TECHNICAL MEMORANDUM

Title: Technical Criteria Variance Application

Name: Hillside at Castle Rock

Number: TCV16-0048

HILLSIDE AT CASTLE ROCK OVERALL DETAIL DRAINAGE PLAN 1

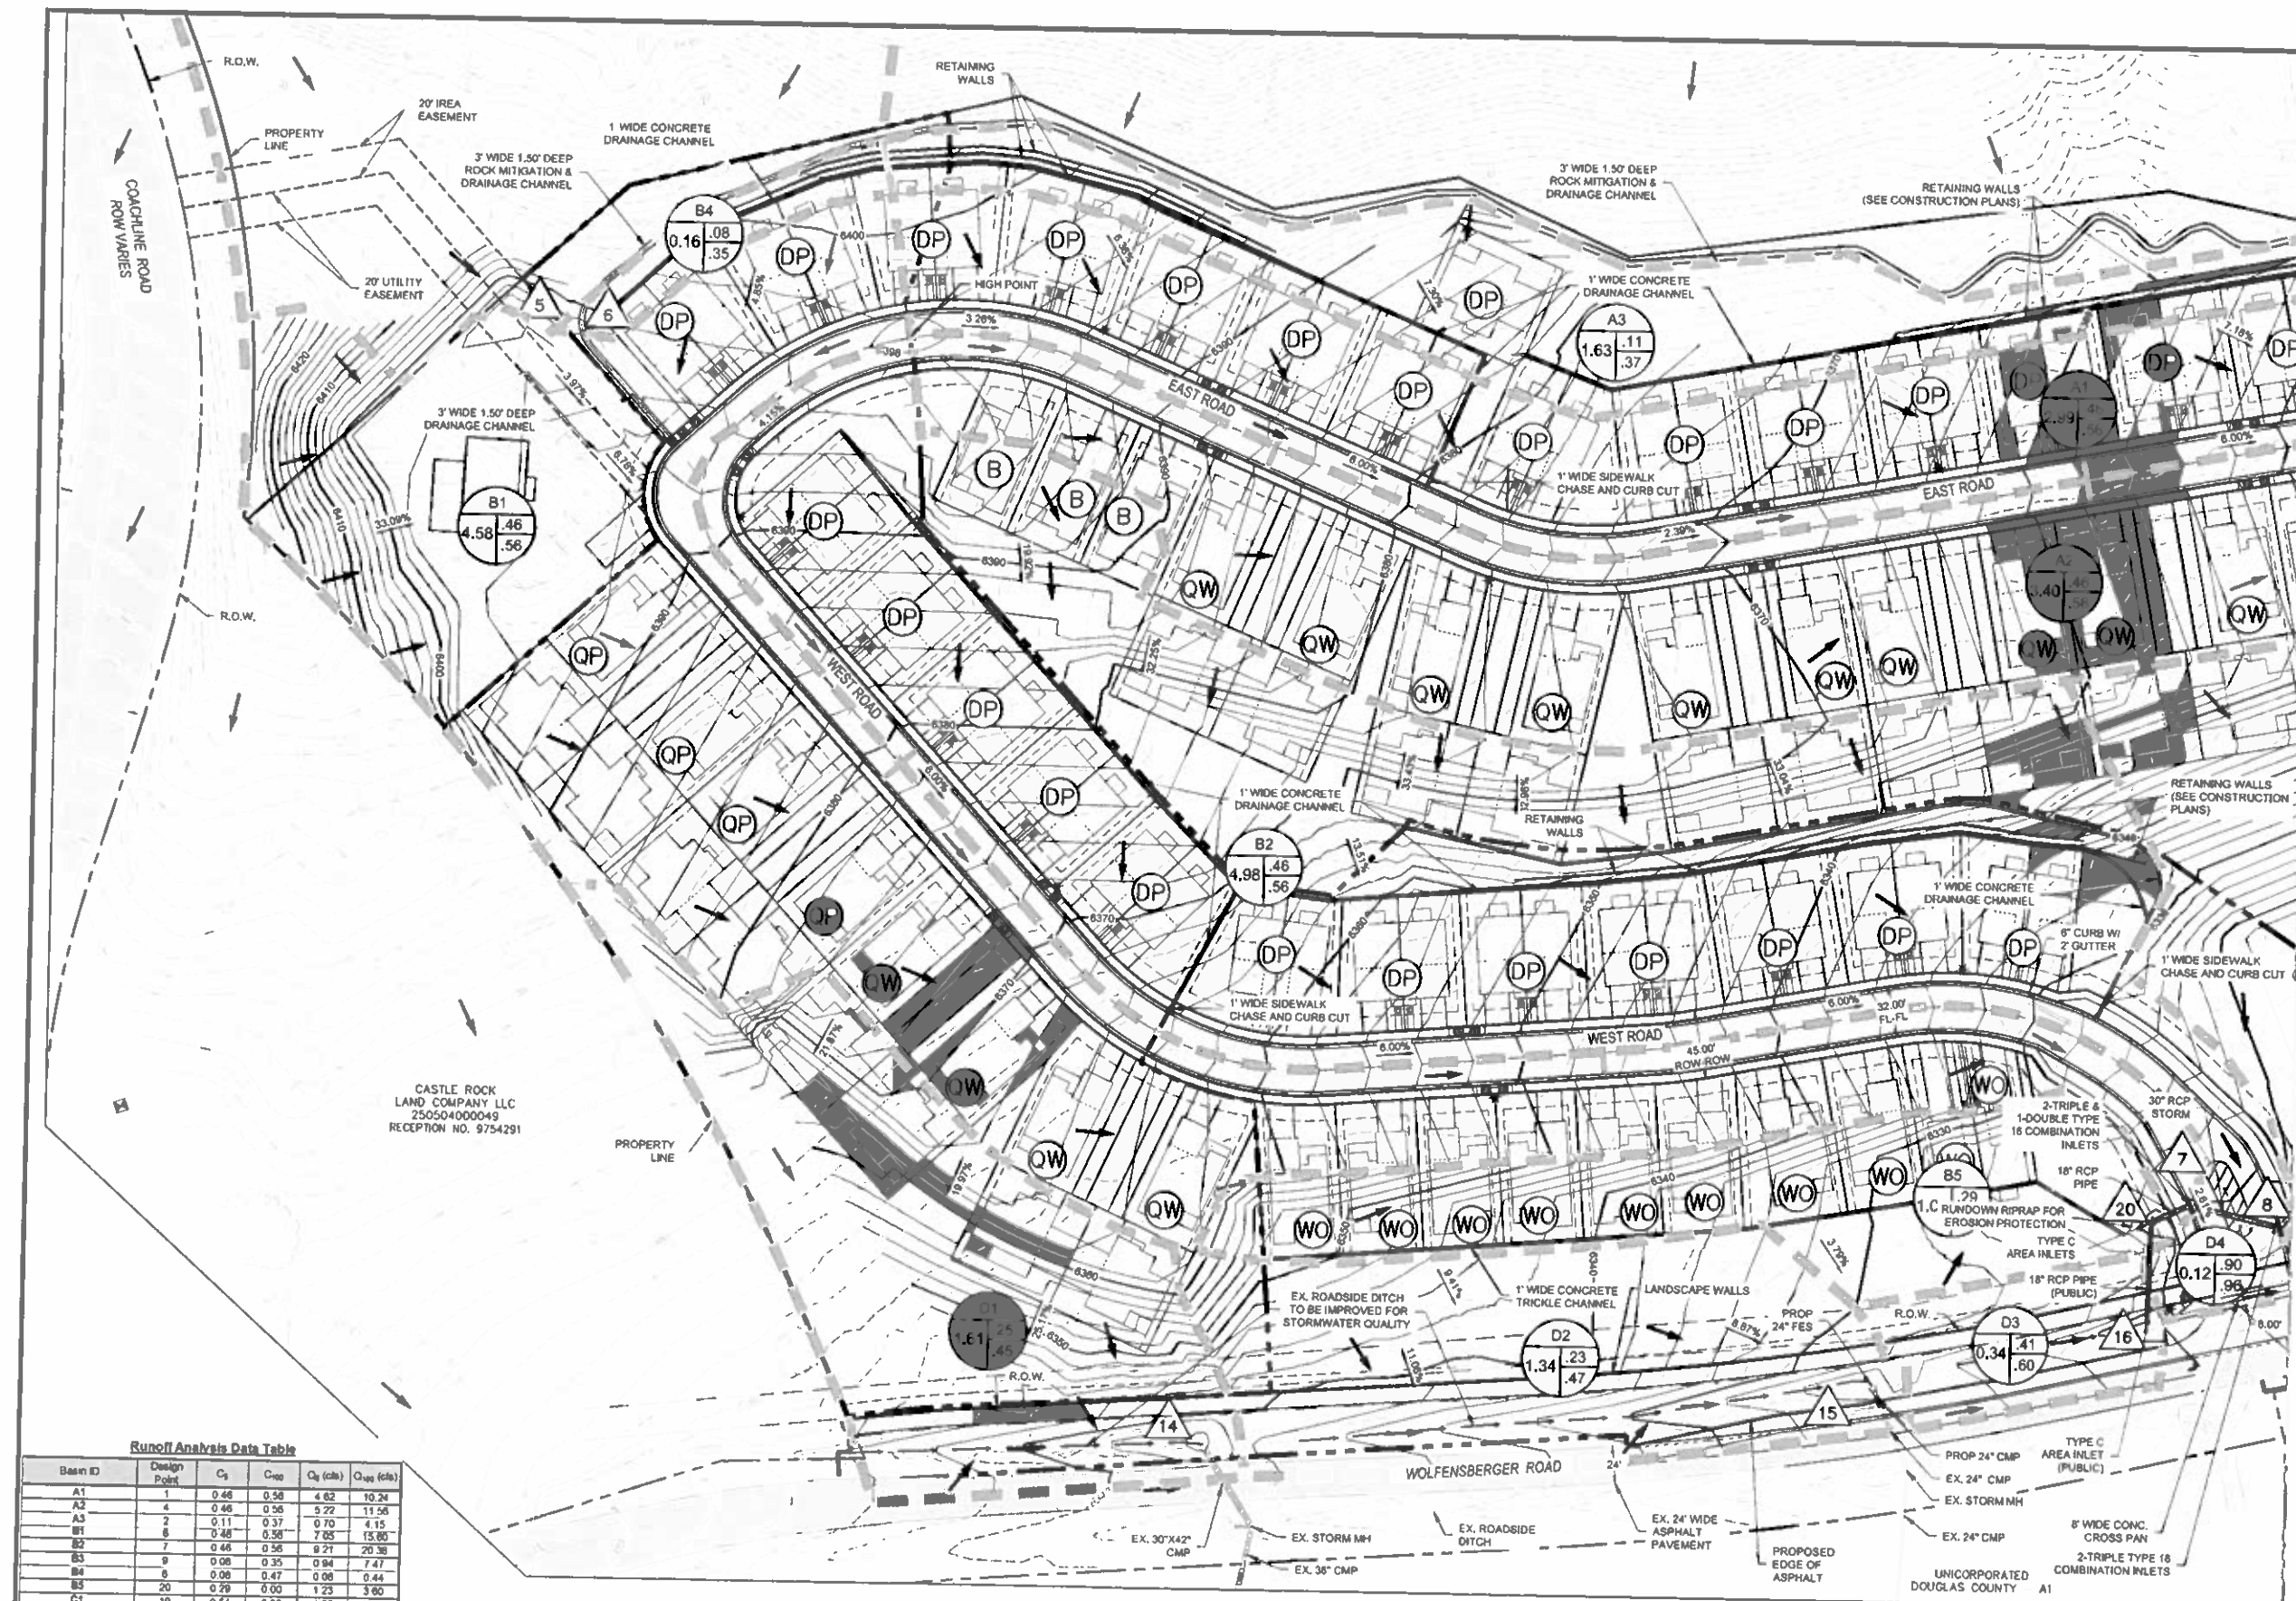
A variance is requested to allow a maximum of 10% of the site runoff not be required to be routed through a water quality feature. Due to the configuration and grading of the site, there is an area at the southeast corner of the site where it is not feasible to route runoff to the onsite water quality facility or through grass lined swales.

The volume of runoff not receiving water quality treatment is minimal.

A variance is requested from the implied requirement that 100% of the developed site area be routed through a water quality facility before exiting the site for Basin C4.

1. Describe the exceptional situation or condition that exists
Basin C4 is located at the SE edge of the site and is located downstream of the onsite detention/water quality facilities and is the lowest area of the site, therefore, it is not possible to route the runoff from Basin C4 through the onsite water quality ponds. See attached exhibit.
2. Describe the difficulty or hardship that would be created by a strict enforcement of the code
Since Basin C4 is: downstream of the onsite water quality facility; the lowest point on the site; runoff flows directly off the property into an existing roadside ditch.
3. Describe why there would not be any adverse impact on public health, safety and welfare
Basin C4 is 0.45 acres and the total developed acreage is 32.15. Basin C4 represents 1.4% of the total developed acreage.

Recommendation: X **Approve** **Deny**

Staff Recommendation: Approved ☒ Yes ☐ No
